BYLAW C-7991-2020**A Bylaw of Rocky View County, in the Province of Alberta, to adopt the Ascension Conceptual Scheme**

SCHEDULE 'A'
FORMING PART OF BYLAW C-7991-2020

A Conceptual Scheme affecting Block 6, Plan 8710757, NE-18-25-2-W5M; Block A, Plan 9212196, SE-19-25-2-W5M; a portion of SE-19-25-2-W5M; and SW-19-25-2-W5M, herein referred to as the Ascension Conceptual Scheme.

Figure 23 - Internal Wastewater Servicing Plan

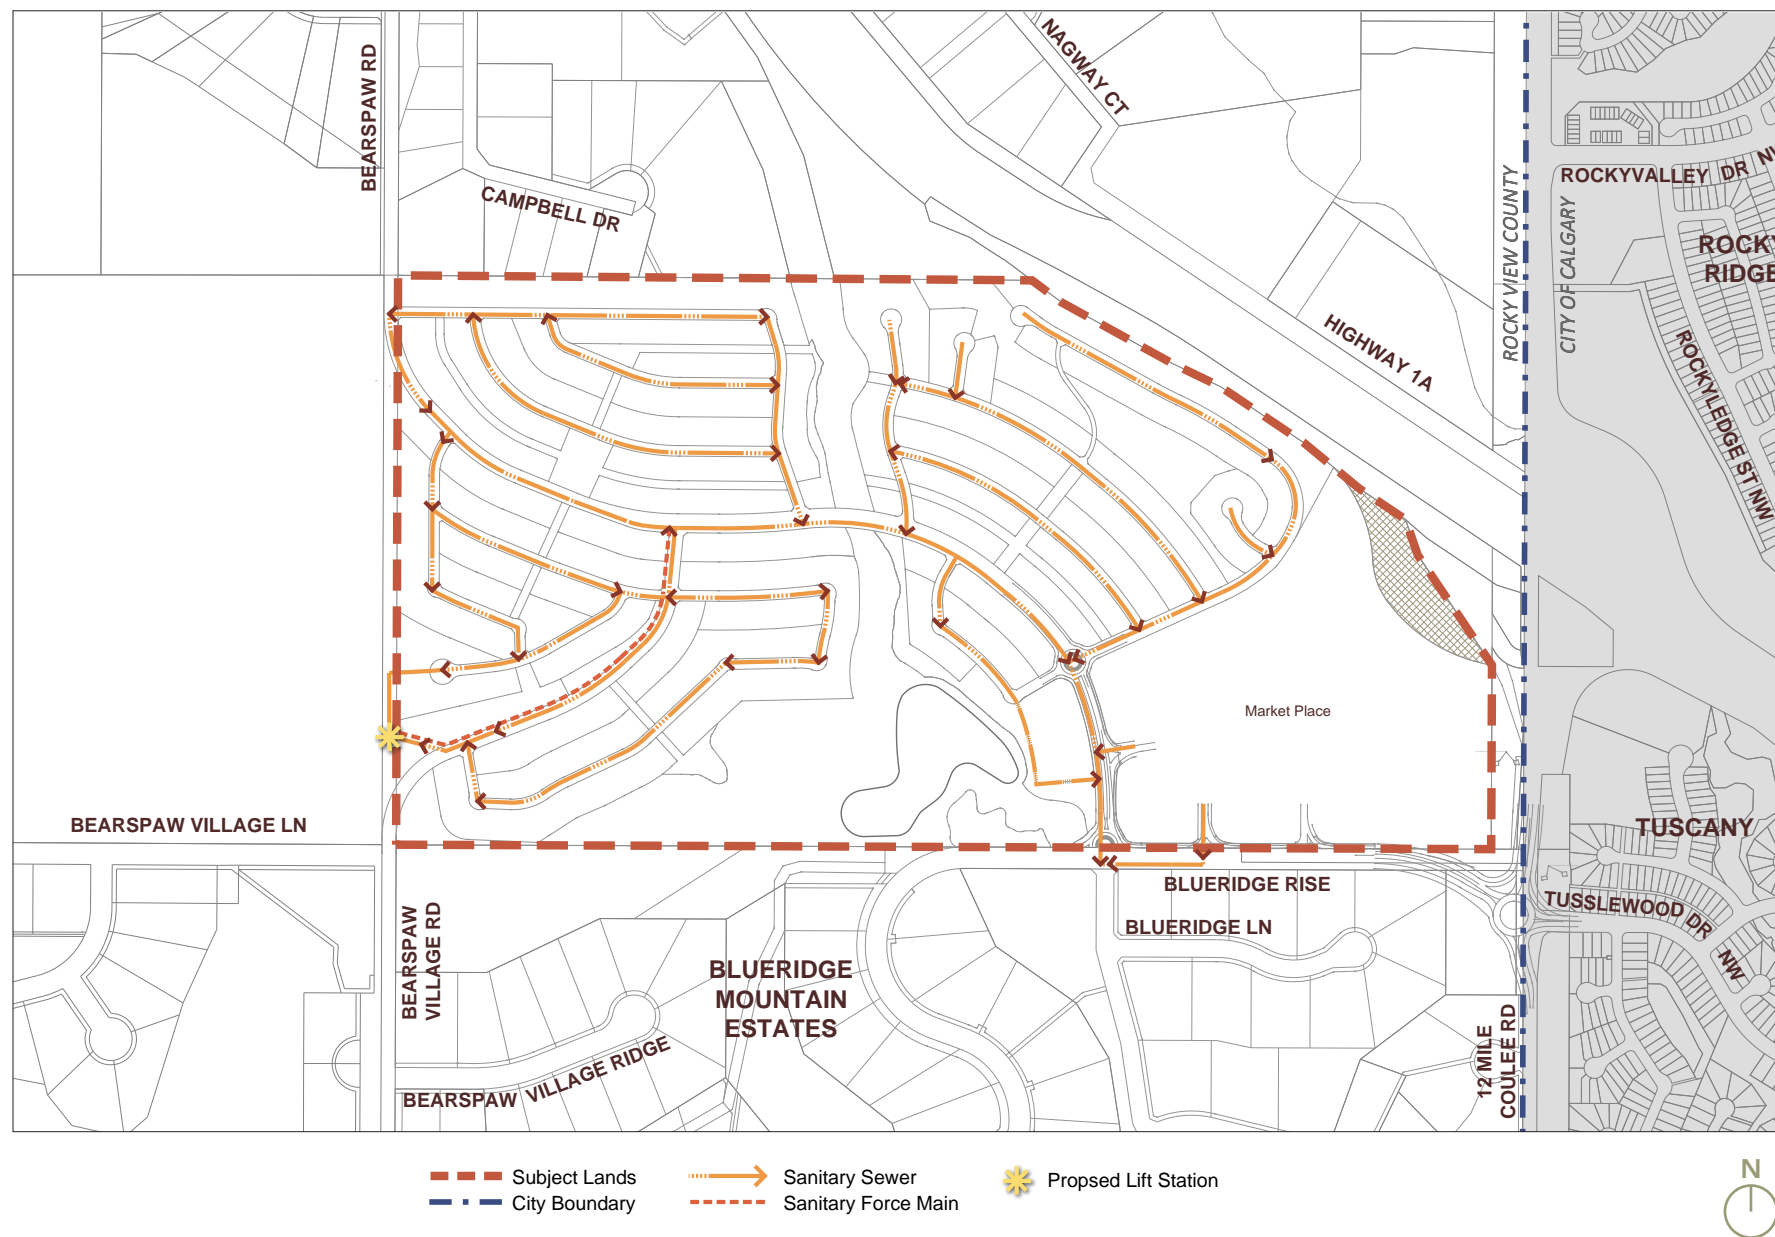
Formerly Figure 24 - Figure was updated
